**UKWIN'S D4 COMMENTS
ON REP3-022 & REP3-040**

(REP3-022: NLGEPL'S D3 COMMENTS ON UKWIN'S D2 WR AND
D2 COMMENTS ON THE RDF SUPPLY ASSESSMENT REV 1,
& REP3-040: RDF SUPPLY ASSESSMENT REVISION 2)

North Lincolnshire Green Energy Park

EN010116

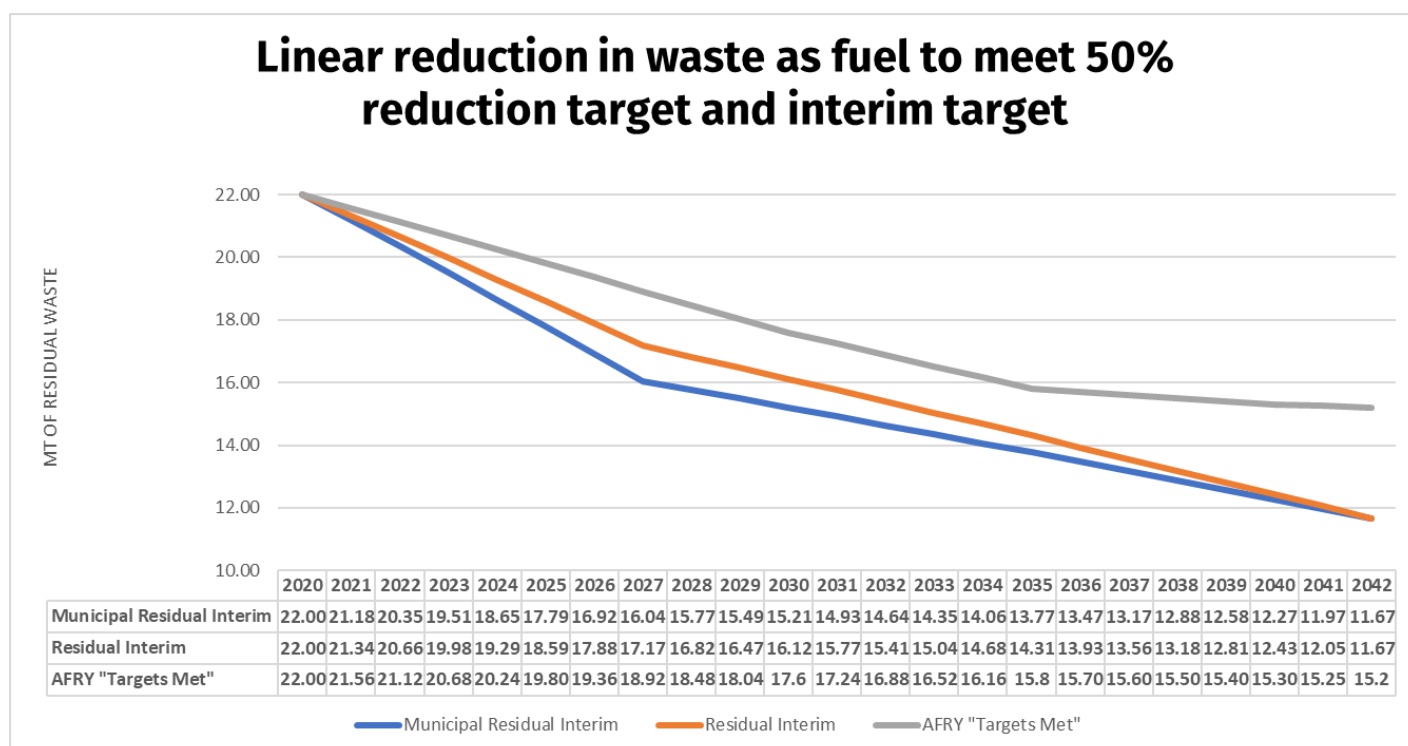
15. Assuming a linear fall between 2020 and 2027, and then another linear fall between 2027 and 2042, would result in waste arisings falling in line with the following chart and table:
